## Chapter 2. Response to Comments on the Public Review Draft MND

This memo contains responses to the comments that the City of San Bernardino (Lead Agency) received on the Mitigated Negative Declaration (MND) for the Hardt and Brier Business Park Project during the public review period, which began November 1, 2023, and closed November 20, 2023 (SCH No. 2023100916). This document has been prepared in accordance with California Environmental Quality Act (CEQA) as amended (Public Resources Code Section 21000 et seq.) and the State CEQA Guidelines (Cal. Code Regs., tit. 14, § 15000 et seq.) and represents the independent judgment of the Lead Agency. This document and the circulated MND together comprise the Final MND.

**Comment Letter 1: Marven E. Norman, Community Member, dated November 20, 2023**

**Comment Letter 2: Supporters Alliance for Environmental Responsibility (SAFER), dated December 13, 2023**

Figure 9: Preferred Bikeway Type for Urban, Urban Core, Suburban and Rural Town Contexts

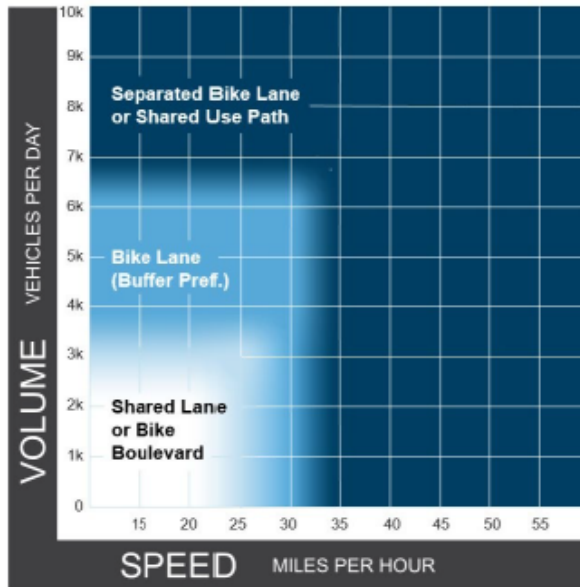
The second concerns is to ensure that the appropriate bike facilities per [the Caltrans guidelines](#) (or similar from FHWA or NACTO) are built.

**Response to Comment 1.2:** This comment states that the commentor has concerns over ensuring that appropriate bike facilities, per Caltrans guidelines, are built.

This comment does not raise a specific issue with the adequacy of the MND or raise any other CEQA issue. The MND discusses alternative transportation in Section 5.17, *Transportation*, page 133 of the MND and states that the proposed Project would provide on-site bicycle parking and would not conflict with alternative transportation such as transit, bicycle, and pedestrian facilities. According to the Final San Bernardino Active Transportation Plan *Bicycle Network* map, Tippecanoe Avenue, east of the Project site, is a proposed Class II bike lane and East Brier Drive is a proposed neighborhood street. No existing bicycle network is located near the Project site. The commentor also refers to Caltrans, NACTO, and FHWA guidelines for bike facilities; however, the provided guidelines are guidance tools and are not required of the proposed Project. According to the Caltrans Contextual Guidance for Bike Facilities Memorandum, attached to the comment letter, the contextual guidance chart does not replace engineering judgement or design standards and it should be used as a decision support tool for scoping active transportation facilities during the project planning phase and identifying corridor-level bicycle needs. The proposed Project is consistent with the required bicycle infrastructure from the City of San Bernardino and has incorporated the appropriate facilities into project plans. Therefore, no further response is required or provided.

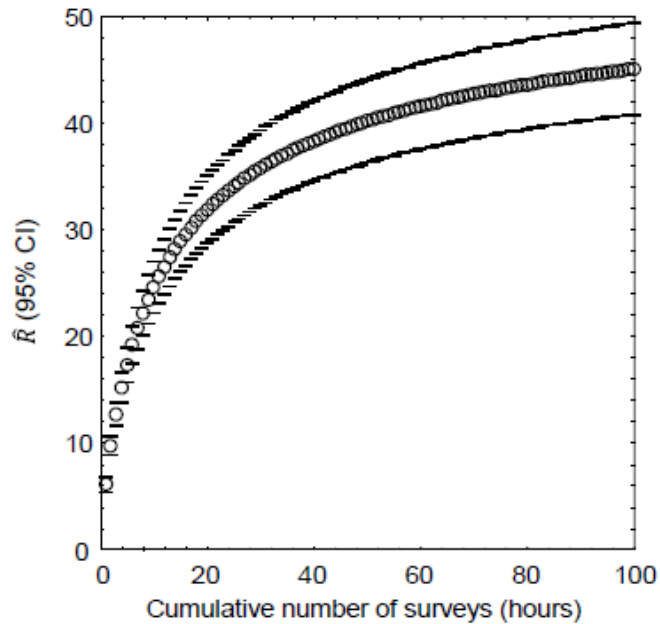
I projected the predictions of each model to thousands of hours to find predicted asymptotes of wildlife species richness. The mean model-predicted asymptote of species richness was 57 after 11,857 hours of visual-scan surveys among the 46 stations of my research site. I also averaged model predictions of species richness at each incremental increase of number of surveys, i.e., number of hours (Figure 2). On average I would have detected 13.2 species over my first 3.18 hours of surveys at my research site in the Altamont Pass (3.18 hours to match the 3.18 hours Noriko surveyed at the project site), which composed 23.15% of the predicted total number of species I would detect with a much larger survey effort at the research site. Given the example illustrated in Figure 2, the 27 species Noriko detected after her 3.18 hours of survey at the project site likely represented 23.15% of the species to be detected after many more visual-scan surveys over another year or longer. With many more repeat surveys through the year, Noriko would likely detect  $27 / 0.2315 = 117$  species of vertebrate wildlife at the site. Assuming Noriko's ratio of special-status to non-special-status species was to hold through the detections of all 117 predicted species, then continued surveys would eventually detect 22 special-status species of vertebrate wildlife.

Because my prediction of 117 species of vertebrate wildlife, including 22 special-status species of vertebrate wildlife, is derived from daytime visual-scan surveys, and would detect few nocturnal mammals such as bats, the true number of species composing the wildlife community of the site must be larger. Noriko's reconnaissance survey should serve only as a starting point toward characterization of the site's wildlife community, but it certainly cannot alone inform of the inventory of species that use the site. More surveys are needed than her one survey to inventory use of the project site by wildlife.

Nevertheless, the large number of species I predict at the project site is indicative of a relatively species-rich wildlife community that warrants a serious survey effort.
